**NEWPORT NEWS REDEVELOPMENT
AND HOUSING AUTHORITY
227 27TH STREET
NEWPORT NEWS VA 23607**

1. Amendment Number 01 of Solicitation Number: IFB #ATP-04-26.
2. Issued by: Monique Warren
3. Responders must acknowledge receipt of this amendment by signing this form below and submitting it with their response.
4. This addendum supplements, modifies, changes, deletes from, or adds to the original bid documents, dated 03/06/26, for Alterations to Pinecroft Apartments, and is herein made part of the bid documents. Modifications to the bid documents associated with this addendum are marked with delta 1 and are dated April 14, 2026. Revised drawings will be provided under separate cover. This addendum consists of three (3) pages, plus attachments.

PRE-BID AND SITE VISIT SIGN IN SHEET
 APRIL 8, 2026 @ 2:00 pm
 PINECROFT-ALTERATIONS AT PINECROFT

SHEET NUMBER
S1.1

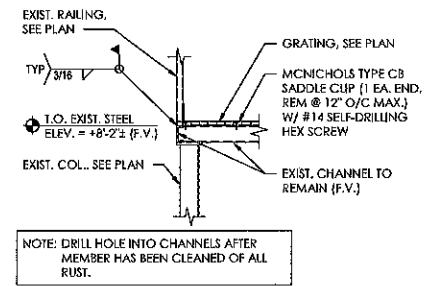
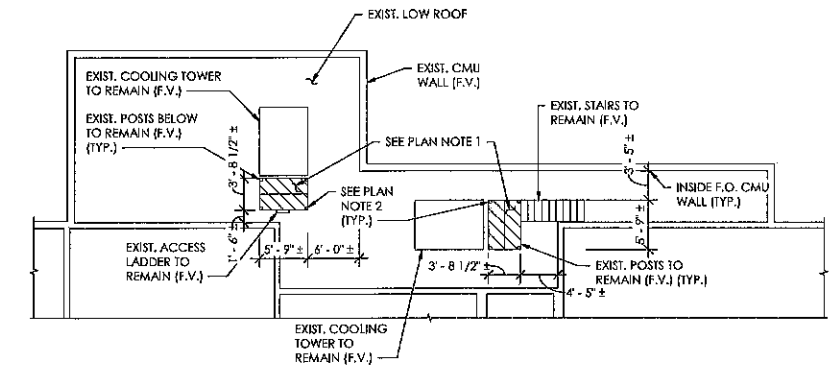
REVISIONS	
NO.	DESCRIPTION
1	8/30/26 ADDENDUM 1
